# Work Order ID 97299

Item Name: 205 Bent Tube

DRAWING NO. D2580	REV. E SHEET 4 OF 8
TITLE 205 SKIDTUBE ASSEMBLY	SCALE NTS

DRAWING NO. D2580	TITLE 205 SKIDTUBE ASSEMBLY	REV. E	DART AEROSPACE LTD ENGINEERING ORDER	D.E.O. NO. D2580-E-1	SHEET NO. SHEET 1 OF 1	SCALE NTS
DRAWN <i>UP</i>	CHECKED <i>ASS</i>	MFG. APPR. <i>EC</i>	APPROVED <i>[Signature]</i>	DE APPR. <i>[Signature]</i>		
DATE 11.12.13	DATE 11.12.13	DATE 11.12.13	DATE 11.12.13	DATE 11.12.13	DATE 11.12.13

**SECTION B-B, F-F, I-I**  
NOT TO SCALE

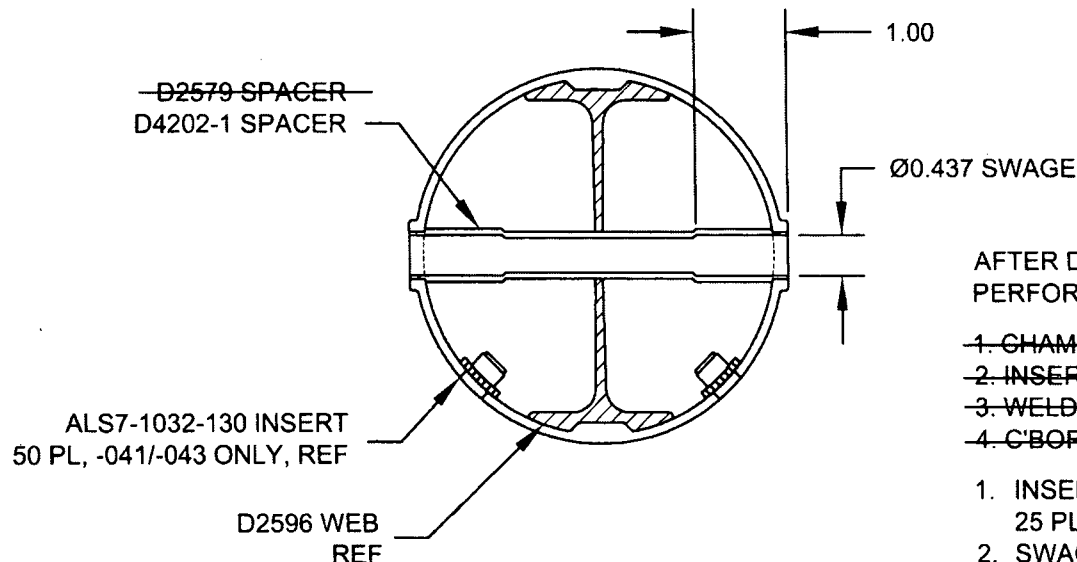
CHANGE ALL C'BORED WELDED CROSSBOLT SPACERS TO SWAGED SPACERS

SECTION B-B, SECTION F-F, & SECTION I-I ARE AMENDED AS FOLLOWS  
FOR ALL HOLES THAT WERE ORIGINALLY C'BORED:

AFTER DRILLING AND BENDING ASSEMBLY  
PERFORM THE FOLLOWING FOR Ø0.508 HOLES ONLY:

1. CHAMFER HOLE 0.050 X 45°
2. INSERT D2579 SPACER (20 PLACES)
3. WELD INTO PLACE AND GRIND FLUSH
4. C'BORE D2579 SPACER TO Ø0.437 X 1.00 DEEP

1. INSERT D4202-1 SPACER, 20 PL (-041) OR 20 PL (-045) OR 25 PL (-047)
2. SWAGE TO Ø0.437 X 1.00 DEEP PER QSI 002
3. TRIM / GRIND FLUSH PER QSI 002
